Vermont Better Roads Grant Program Application

Wells Brook / McCoy Rd

McCoy Road

From: Carvajal, Joshua <Joshua.Carvajal@vermont.gov>
Sent: Monday, April 11, 2016 1:59 PM
To: Tinmouth Town Office
Subject: Tinmouth_McCoy Road Embankment
Attachments: rv_riversroads_fieldguide_SRW_image¬es.pdf; rv_riversroads_fieldguide_SRW_detail.pdf; Tinmouth_McCoy Road Atlas Map.pdf

McCoy Rd
Town of Timmuth
Not to Scale

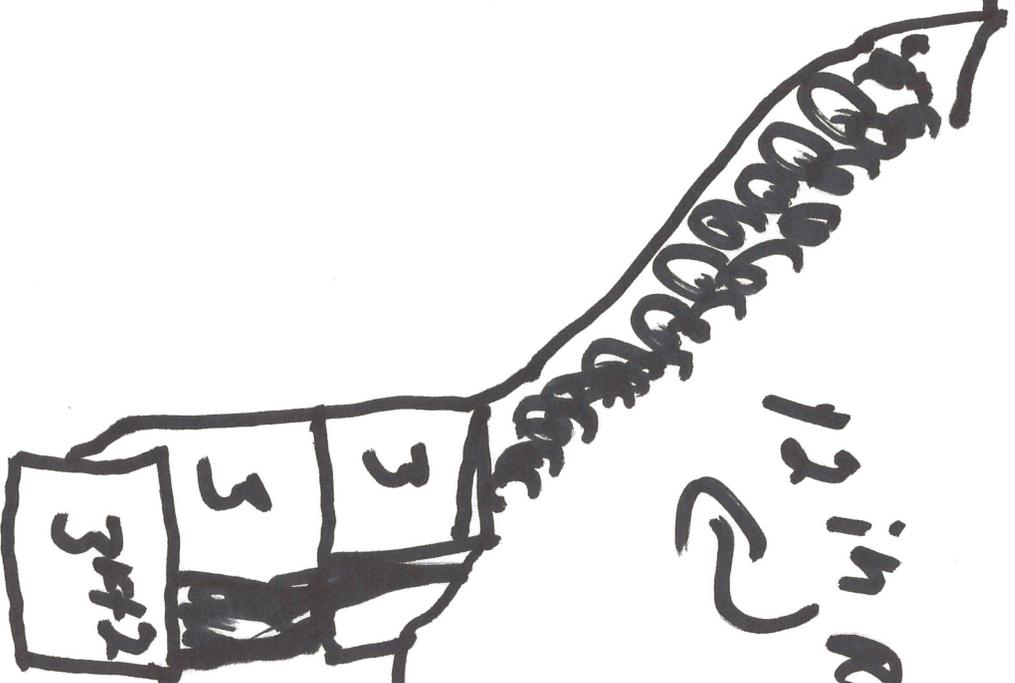
The roadside is sliding into the stream due to erosion at the toe of the slope and though riprap armoring has been placed to protect the road, additional erosion is occurring. I recommend a Stacked Rock Wall be constructed adjacent to the stream then stone fill be placed on the slope above up to the road edge. Please see attached detail sheets for this practice.

Grading the road surface so it drains away from the stream and into the roadside ditch will also prevent washouts along the edge of the road. This portion of the project and any roadside ditch armoring or drainage culvert replacement will not require permit coverage.
